SUBJECT: PALO VERDE NUCLEAR GENERATING STATION, UNITS 1, 2, AND 3 -
ISSUANCE OF AMENDMENTS RE: ADMINISTRATIVE CHANGES TO
FACILITY OPERATING LICENSES AND TECHNICAL SPECIFICATIONS (TAC
NOS. ME2587, ME2588, AND ME2589)

AMENDMENT TO FACILITY OPERATING LICENSE

ATTACHMENT TO LICENSE AMENDMENT NOS. 179, 179, AND 179

Figure 3.4.1-1

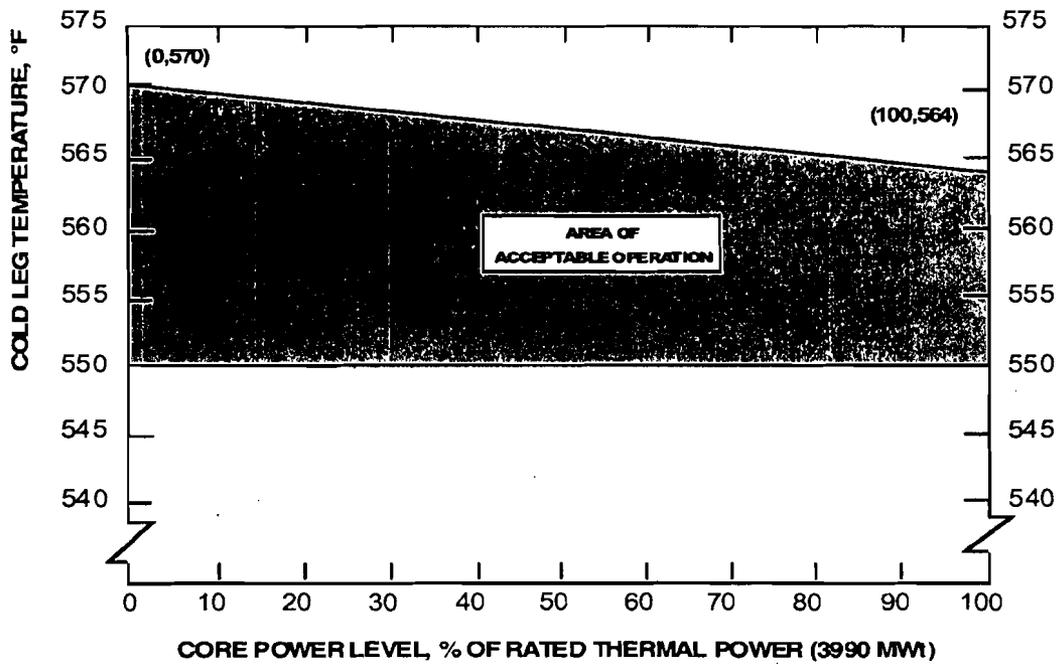
In current TS 3.4.1 and TS 3.7.1, there are labels for a graph and a table column, respectively, that distinguish that graph and column from information relating to 3876 MWt. The licensee also requests that those labels be removed since there will no longer be any information relating to 3876 MWt. Furthermore, the licensee proposes to remove the reference to 3876 MWt in
